Affected/Interested Party Ref [20035315]

DEADLINE 1 WRITTEN REPRESENTATIONS on behalf of Bellway Homes Ltd with regards to Land North of South Ockendon:

DCO Application
 T8010022/APP2 Z
 LAND IS,MS
 REGULATION (S2K1)
 SHEET 39

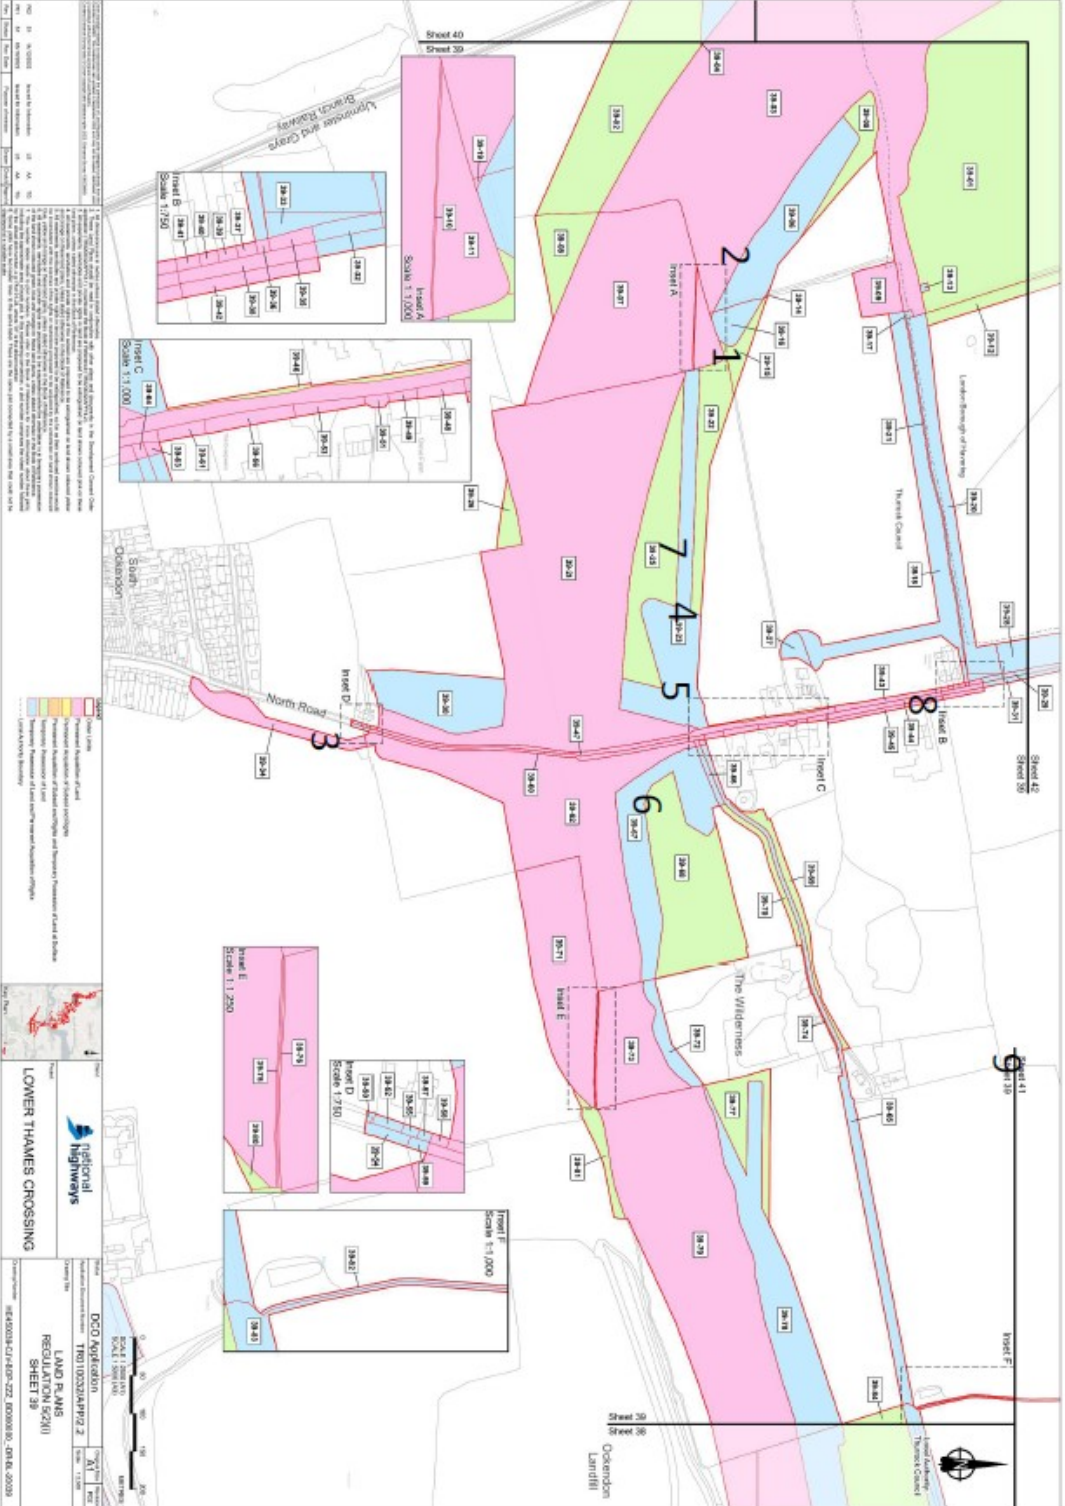
1. As previously advised, the LTC has potentially significant impacts upon the delivery of housing on the land to the North of South Ockendon. The land being promoted by Bellway Homes is situated to the West of North Road and to the North of West Road. The Western boundary abuts the railway line to the east of South Ockendon. Through the emerging Local Plan Thurrock Council have identified South Ockendon, including the land over which Bellway Homes has an option, as having potential for large scale strategic growth comprising approximately 10,000 homes. The land over which Bellway has an option could deliver a significant number of these, however due to the LTC severing the option site Bellway may now only be able to deliver approximately 1,000 homes and approximately 20 acres of employment land. Noise generated by the LTC needs to be sufficiently mitigated. National Highways has responded on this point to Bellway, however, this remains a concern. Additional mitigation in the form of acoustic barriers have been discounted by National Highways as being unnecessary in this area, something that we believe still requires further consideration.

2. The proposed LTC will also sever the existing watercourse drainage that serves the northern parcel within Bellway's option land. This currently drains via a number of ditches and drains in a southerly direction under the proposed LTC. Therefore, to prevent the northern parcel being completely sterilised, suitable alternative surface water and foul drainage must be provided by National Highways to ensure that its existing uses can continue and to allow for its future development. Appropriate legal rights must also be granted over land that is to be transferred to National Highways to facilitate this drainage and to ensure its ongoing maintenance.

National Highways has since confirmed that the intention is for the ditch alongside the LTC to take surface water flows from the "northern parcel" of the site and that further engagement with the landowner is expected to occur. To date, we remain concerned that the discharge rate of the existing land has not been taken into account within the design of the drainage ditch, and that confirmation that the ditch can both take the predicted flows and allow for drainage from the northern parcel is required. We also remain concerned about how foul water from the northern parcel would connect to the existing foul water network – with the route of the LTC severing routes to the south. Should discharge into the ditch not be available then allowance within the design needs to be made for a conduit under the LTC to allow for both surface and foul water flows in the future as there are no alternative surface water discharge points or foul sewer networks north of the proposed LTC route.

3. Bellway understand that the objective of the public right of way route along north Road is required to connect settlements and populations. They however still object to the requirement for the permanent acquisition of land to deliver a footpath connection between the LTC and the northern edge of the existing built-up area of South Ockendon. Bellway welcome National Highways intention to consider a voluntary agreement regarding land ownership to ensure that future development and access is not constrained. We would wish to further such discussions on this matter and reserve our position in relation to our concerns on this matter.

4. Whilst the reduction in the extent of land required for the Development Order is welcomed, it is unclear what the remaining areas identified are intended for, and in the case of the temporary possession, the envisaged duration of their possession. We request further clarity in this regard. Bellway also requests confirmation and details of the diversion of the various pipelines that run to the north of and under the proposed LTC within Bellways option land. This aspect remains, and Bellway's position is unchanged.

5. In the absence of information, it is entirely unclear why the temporary possession of this land, alongside permanent acquisition rights, would be required. This land represents an increase in the extent of land required for the proposed Development Order to the north of the LTC and is entirely without explanation. We note that National Highways had previously advised that the projection southwards from this strip of land would be required to enable an electricity connection to the northern compound. We have previously made submissions on this point, so please refer to the Community Impactions Consultation appended to this response for further detail on this. Bellway also requires confirmation that National Highways proposed multi-utility works, temporary possession and acquisition of rights will not adversely impact on the proposed access onto North Road from the northern parcel (north of the proposed LTC) as it is necessary for Bellway to maintain the ability to create an access point from the North Road across the proposed multi-utility corridor that runs parallel to North Road. It is requested that where land or rights are acquired by National Highways, suitable rights are reserved to facilitate the existing and proposed access arrangements to cross land with permanent rights.
